Staff Report & Recommendation

Historic Preservation Board

SUBJECT: HPB24-0632, **1730 Jefferson Avenue.**

An application has been filed requesting a Certificate of Appropriateness for the partial demolition and renovation of the existing home and accessory buildings including the construction of attached additions and variances from the required setbacks, lot coverage, unit size and open space requirements.

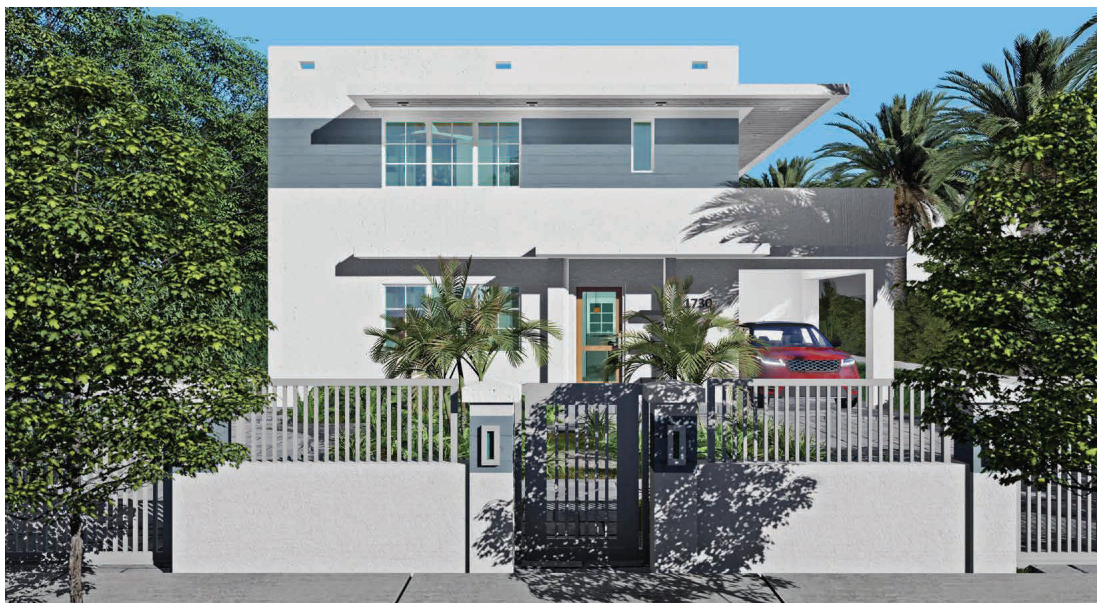
Standard 2: The applicant is proposing modifications to the primary façade of the home that are inconsistent with the original design.

- a. Exterior architectural features.
Not Satisfied
The applicant is proposing modifications to the primary façade of the home that are inappropriate and inconsistent with the original design.

On April 22, 2025, the Historic Preservation Board reviewed and continued the subject application to a date certain of June 17, 2025. Since the April hearing, the applicant has submitted revised plans including the following modifications:

- The front façade of the home has been further refined including:
 - The retention of the racing stripes at the second level.
 - The introduction of historically accurate window muntins.
 - The proposed eyebrow/overhangs have been lowered closer to the top of the existing openings.

- The trim color has been lightened.
- The design of the front wall has been revised to include vertical pickets.
- The rear accessory building rooftop addition has been revised to comply with the required 15'-0" rear accessory building setback resulting in a reduction of the unit size variance request and the elimination of the rear accessory building setback, rear yard open space and rear yard lot coverage variances.

Staff remains supportive of the proposed additions which will not be visible from Jefferson Avenue. Further, staff believes that the modifications to the front façade of the home, as outlined above, are more consistent with the original design. Staff continues to be concerned, however, with the proposed new overhangs which are disconnected from the window and door openings and are not consistent with the original design. As such, staff recommends that the primary façade be retained and restored consistent with available historic documentation, inclusive of the retention and restoration of the existing eyebrows, or their reconstruction.

1. Revised elevation, site plan and floor plan drawings shall be submitted, and at a minimum, such drawings shall incorporate the following:
 - a. The primary (east) façade of the home shall be restored to the greatest extent possible, consistent with available historical documentation, in a manner to be reviewed and approved by staff consistent with the Certificate of Appropriateness Criteria and/or the directions from the Board.
